HISTORIC AND DESIGN REVIEW COMMISSION

August 16, 2023

HDRC CASE NO: 2023-244
ADDRESS: 328 MADISON ST
LEGAL DESCRIPTION: NCB 744 BLK 3 LOT 18
ZONING: RM-4, H
CITY COUNCIL DIST.: 1
DISTRICT: King William Historic District
APPLICANT: George Torres III | George Torres Architect PLLC
OWNER: Scott & Mary Wells
TYPE OF WORK: Conceptual review of porch floor replacement, porch roof replacement, partial demolition, rear porch addition, fenestration changes, hardscaping, fencing, and ADU modifications
APPLICATION RECEIVED: June 16, 2023
60-DAY REVIEW: August 29, 2023
CASE MANAGER: Bryan Morales

328 MADISON ST. REMODEL + IMPROVEMENTS

2 PROPOSED SITE PLAN
1/16" = 1'-0" TRUE NORTH

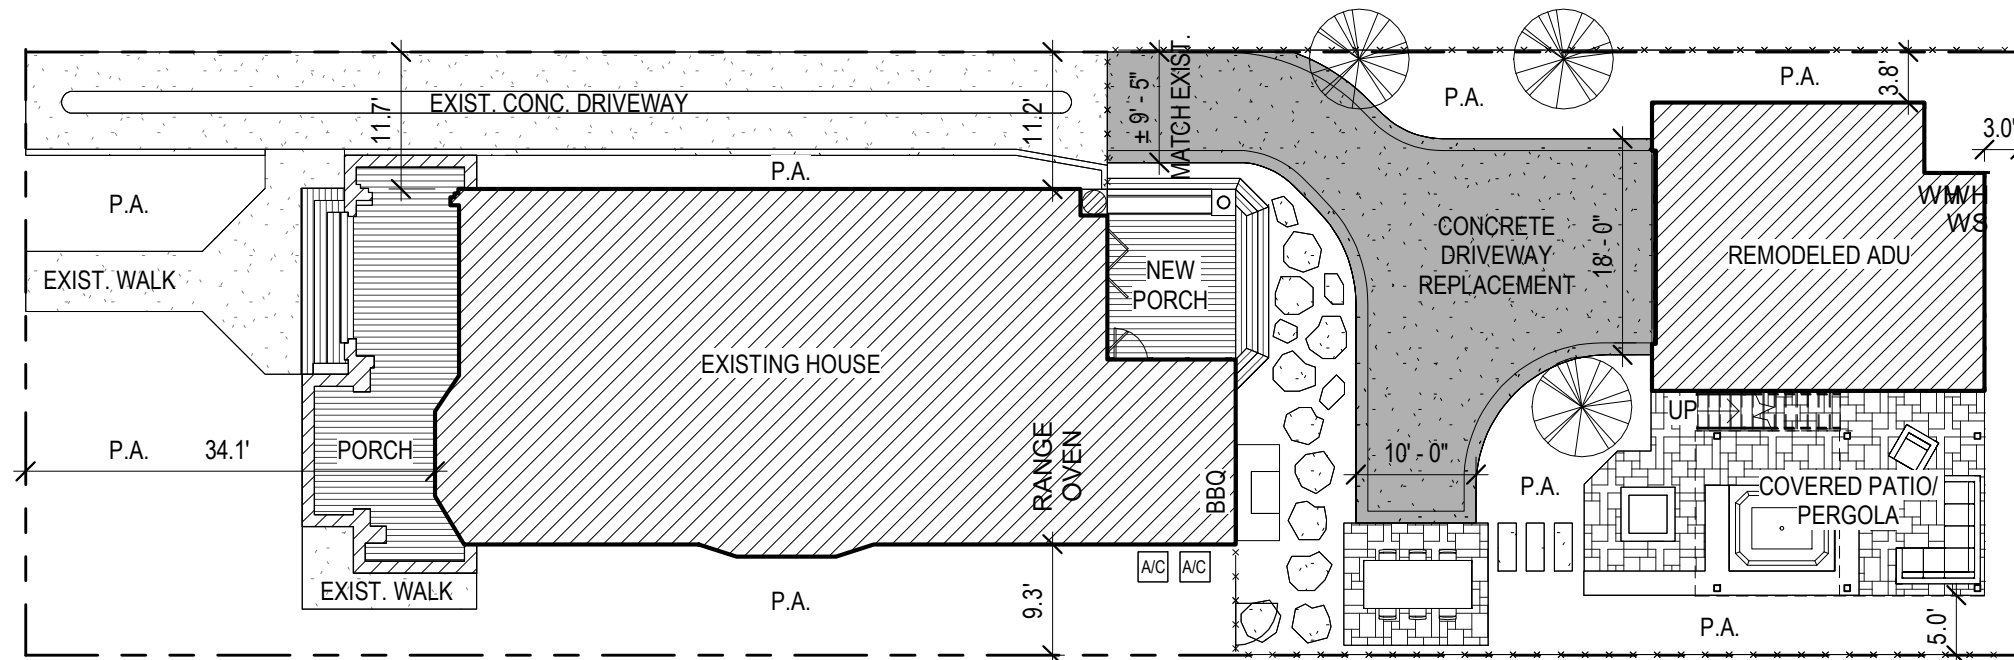
- g. HARDSCAPING – The applicant is requesting conceptual approval to modify the rear yard by introducing stone pavers and a concrete driveway. The Historic Design Guidelines for Site Elements 3.B.i. states to not introduce large paves, asphalt, or other impervious surfaces where they were not historically located. Guidelines for Site Elements 3.B.ii. states that new pervious hardscapes should be limited to areas that are not highly visible, and should not be used as wholesale replacement for plantings and if used, small planting should be incorporated into the design. Staff finds the driveway installation and paver installation to generally conform to guidelines; however, a measured landscape site plan will be needed for final approval.

- h. FENCE REPAIR – The applicant is requesting conceptual approval to repair the fence and gate. If the repair is done in-kind, this scope of work would be eligible for administrative approval. Staff requires a site plan and material description for final approval.

- v. That the applicant retain the door configuration on the east and north elevation and repair any damage in-kind.
- vi. That the applicant submit a measured landscape plan showing that the proposed hardscape elements allow for 50% natural greenery.

- vii. That the applicant submit a measured site plan and material details for the replacement or repair of the existing fence.
- viii. That the applicant spot repair the horizontal wood siding on the ADU.

2 REAR PORCH ROOF PLAN
1/8" = 1'-0"

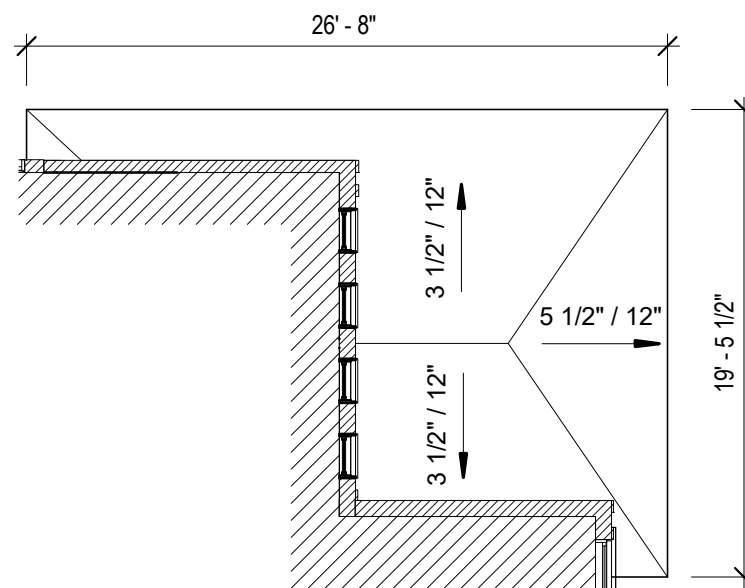
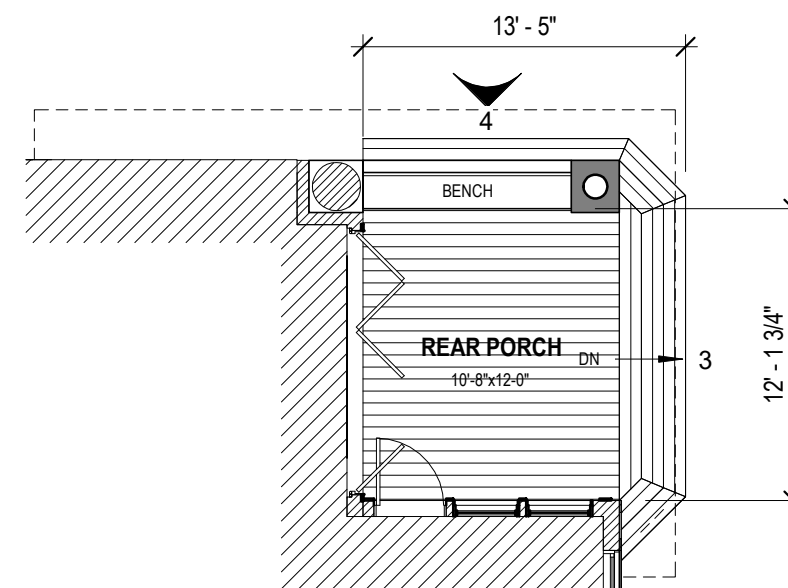
- d. REAR PORCH (DEMOLITION & MATERIALS) – The applicant is requesting conceptual approval to demolish the rear deck and replace the wood flooring with composite PVC decking material and to install an architectural shingle roof. In addition, the applicant is proposing to install one rear porch column to match the existing one at the rear. Exterior Maintenance and Alterations 7.A.iii. states to preserve original wood or concrete porch floors and 7.B.iii. states to replace in-kind porch elements such as ceilings, floors, and columns, when such features are deteriorated beyond repair. In addition, Exterior Maintenance and Alterations 3.B.iv. states to replace roofing materials in-kind whenever possible when the roof must be replaced and to match new roofing materials to the original materials in terms of their scale, color, texture, profile, and style, or select materials consistent with the building style, when in-kind replacement is not possible. Staff finds that the proposed installation of composite PVC decking material does

4 NORTH ELEVATION
1/8" = 1'-0"

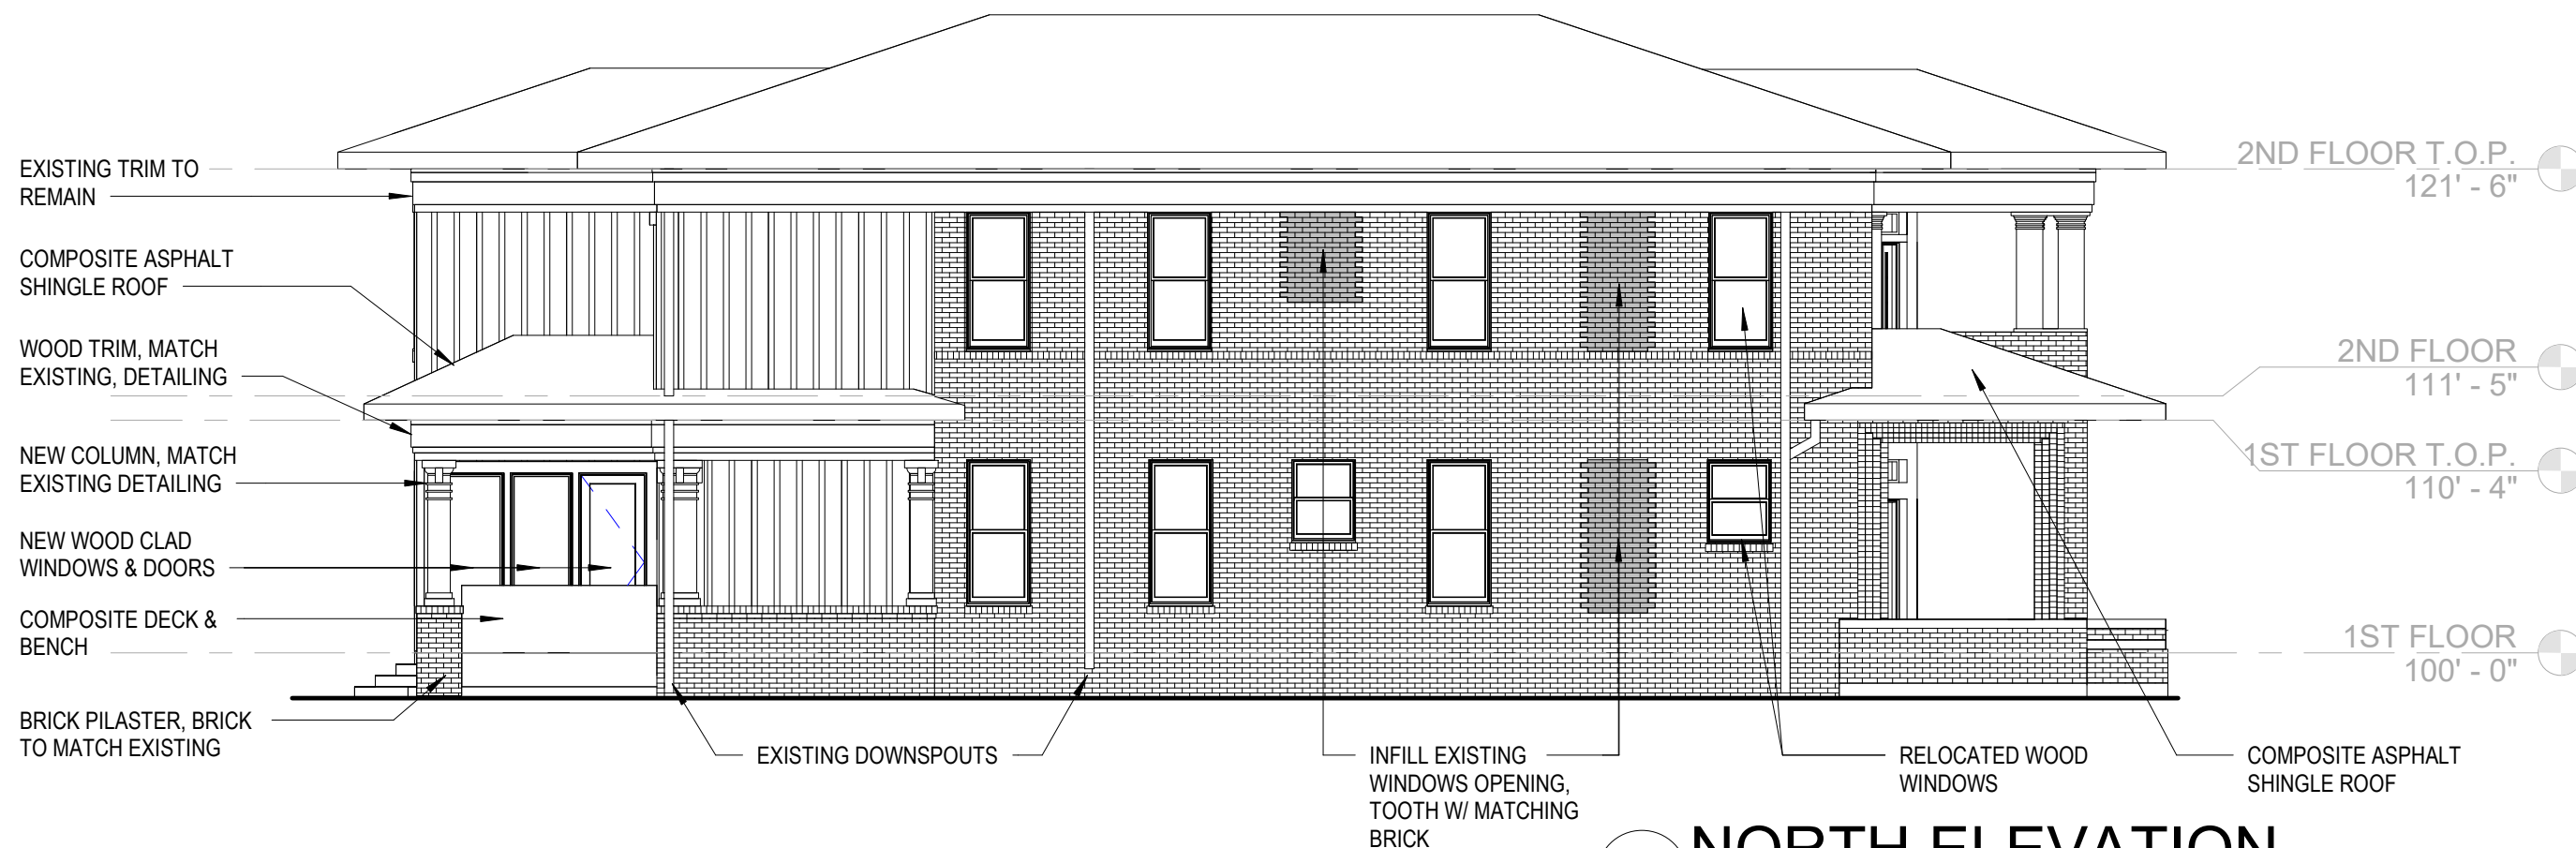
- i. FENESTRATION MODIFICATIONS (NORTH FAÇADE) – The applicant is requesting to infill three historic window openings and relocate two of the windows to a new location on the same façade. Guidelines for Exterior Maintenance and Alterations 6.A.i. states to preserve existing window and door openings. Staff finds the fenestration modifications to the north façade of the primary structure generally does not conform to guidelines.

ROOF PLAN -
ADU GARAGE
APARTMENT

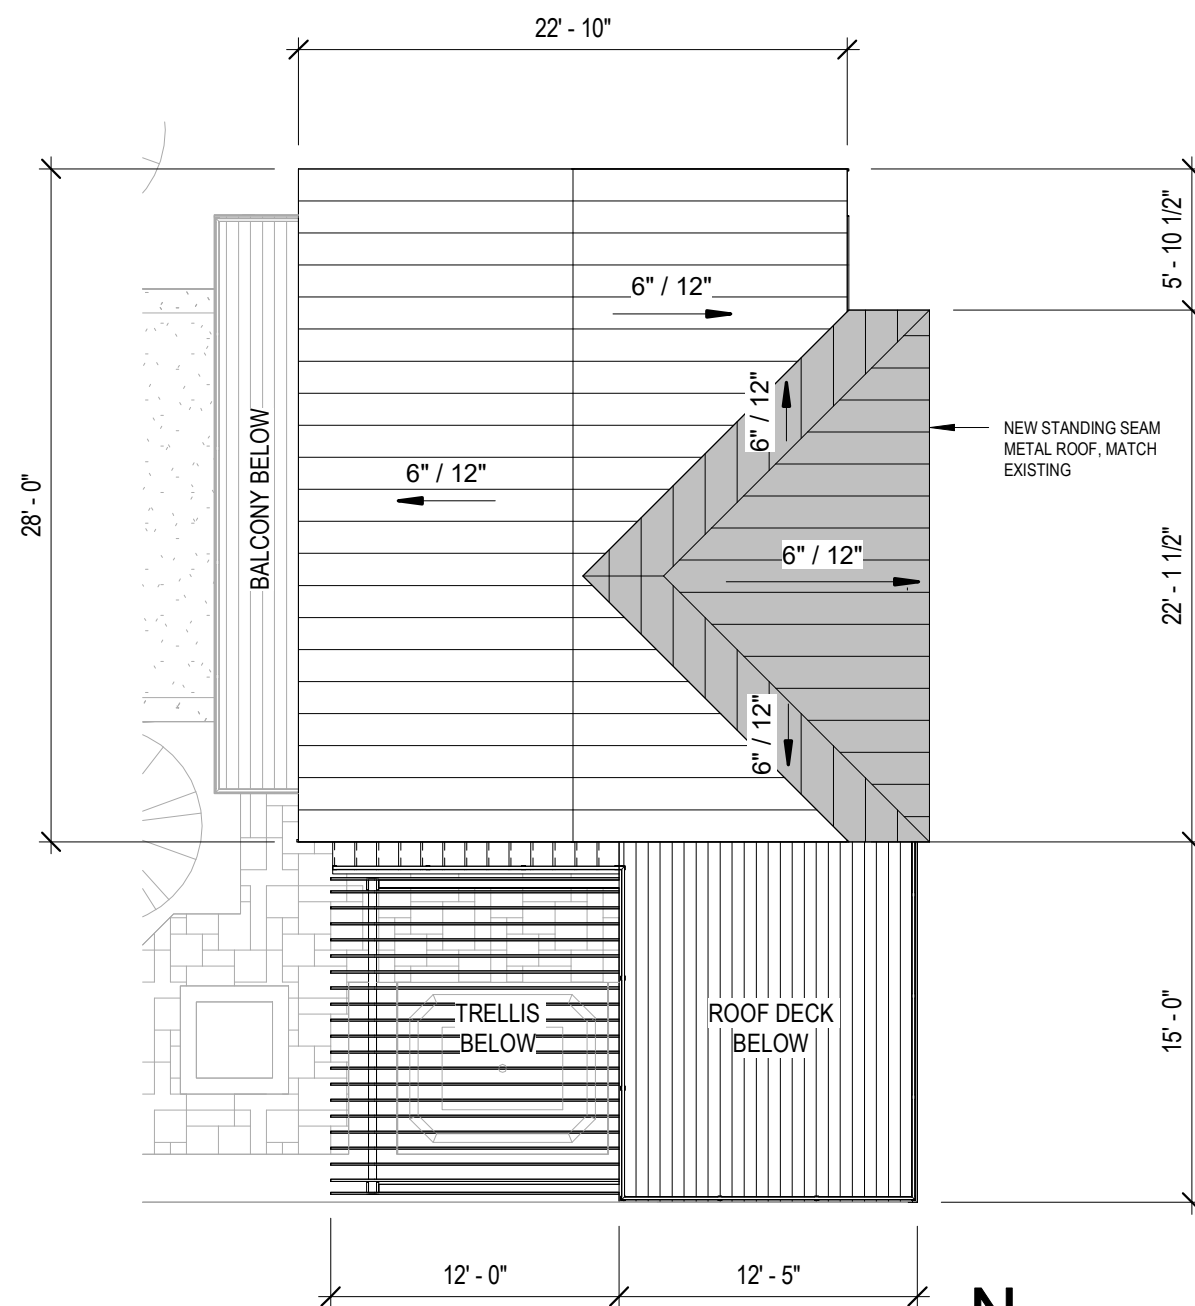
- p. ADU ROOF FORM – The applicant is requesting conceptual approval to modify the historic roof form of the detached accessory. The Historic Design Guidelines for Exterior Maintenance and Alterations 3.B.ii. states to preserve the original shape, line, pitch, and overhang of the historic roofs. Staff finds the modification of the roof form is generally appropriate.

2 SOUTH ELEVATION
1/8" = 1'-0"

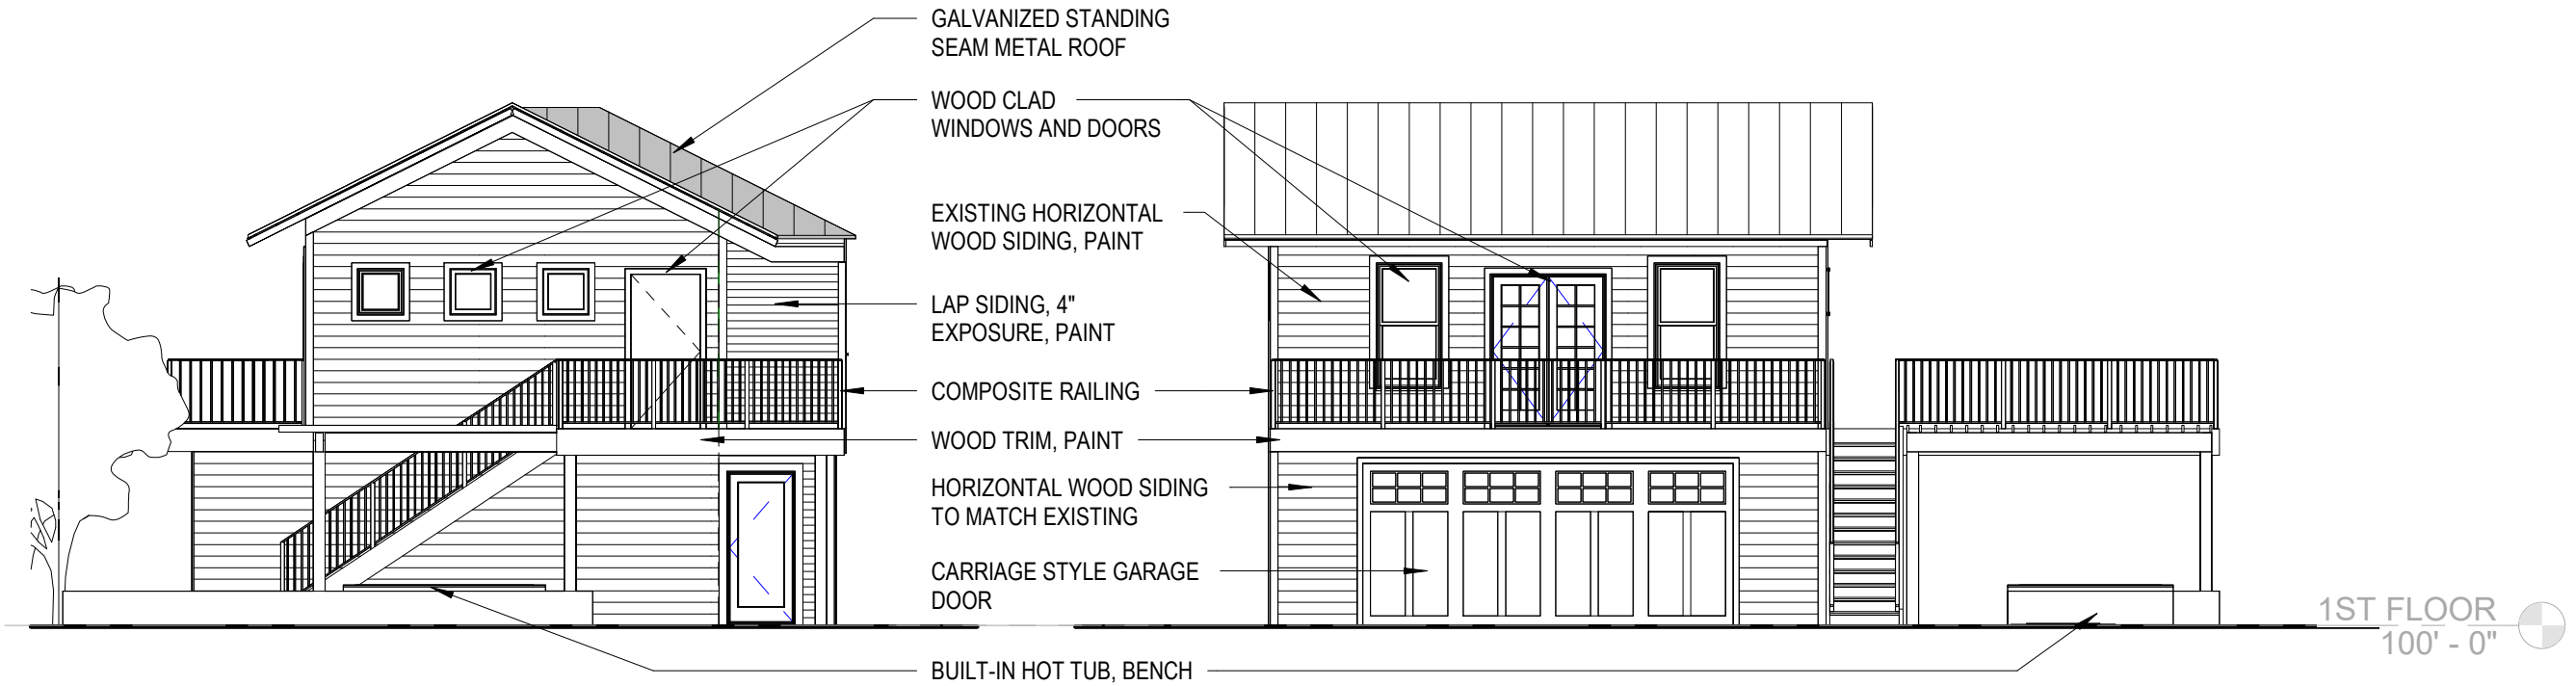
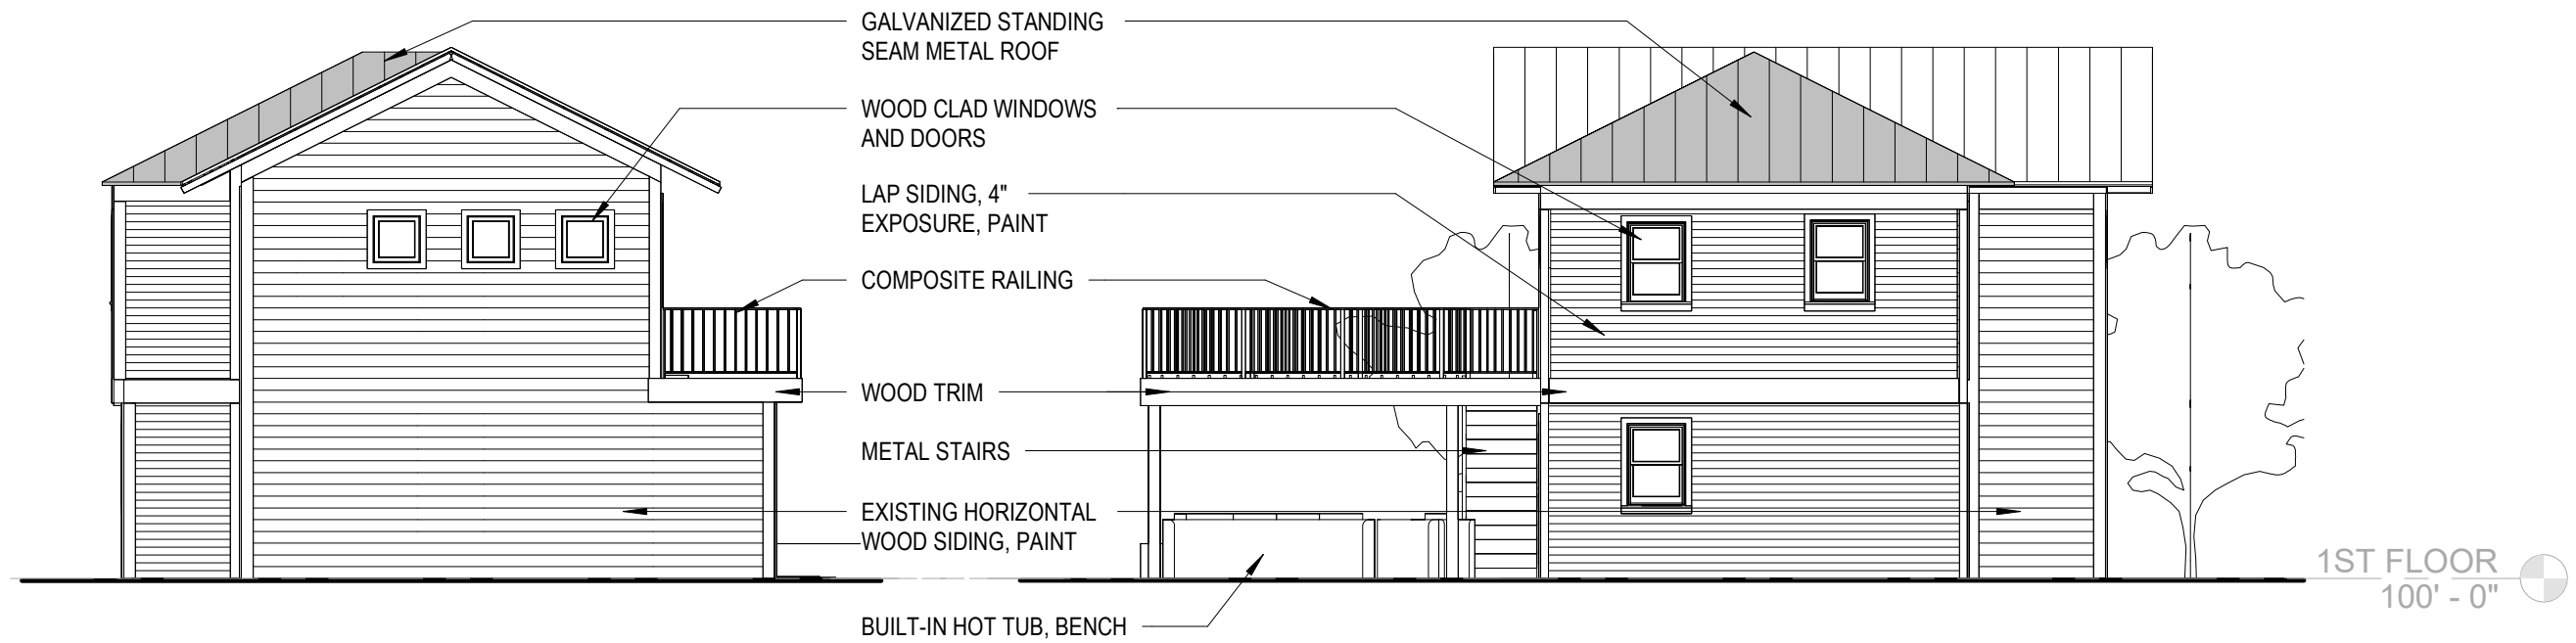
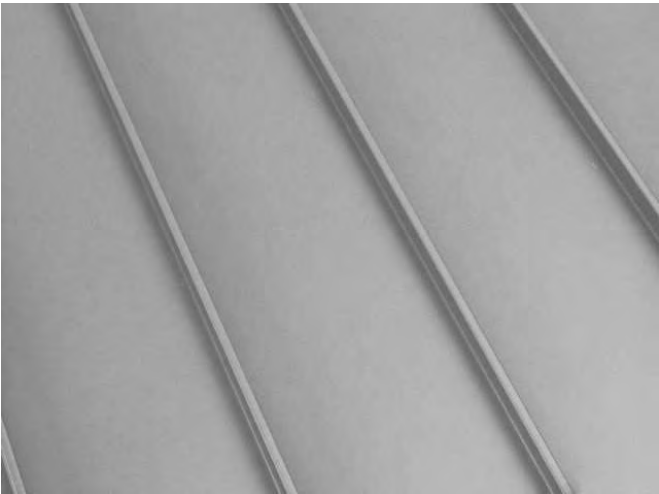
- k. ADU (FENESTRATION PATTERN) – The applicant is requesting conceptual approval to modify the fenestration patterns of the south, west, north, and east elevations of the detached accessory. The Historic Design Guidelines for Exterior Maintenance and Alterations 6.A.i. states to preserve existing window and door openings. Staff finds the fenestration modifications on the accessory does not conform to guidelines.

- l. ADU WINDOWS (MATERIAL) – The applicant is requesting conceptual approval to remove the existing wood windows and replace with new wood windows. Exterior Maintenance and Alterations 6.A.iii. states to preserve historic windows. Staff finds the material of the proposed windows generally conform to guidelines; however, historic windows should be retained and repaired in-kind.

- m. ADU SIDING – The applicant is requesting conceptual approval to either remove and replace or repair the horizontal siding on the structure. Exterior Maintenance and Alterations 9.A.ii. states to repair outbuildings and their distinctive features in-kind and when new materials are needed, they should match existing materials in color, durability, and texture. Staff finds the wholesale removal of siding does not conform to guidelines.

- n. ADU GARAGE DOOR – The applicant is requesting conceptual approval to remove the split bay garage doors and central entry door and replace the area with one carriage garage door. Exterior Maintenance and Alterations 9.B.i. states to ensure that replacement garage doors are compatible with those found on historic garages in the district as well as with the principal structure. When not visible from the public right-of-way, modern paneled garage doors may be acceptable. Exterior Maintenance and Alterations 6.A.i. states to preserve existing window and door openings. Staff finds the replacement of the garage doors and the introduction of one garage door opening does not conform to guidelines.

- o. ADU BALCONY – The applicant is requesting conceptual approval to construct a balcony on the south and west elevations. Guidelines for 7.A.i. states to not add new porches, balconies, or porte-cocheres where not historically present. Staff finds the installation of the balconies does not conform to guidelines.
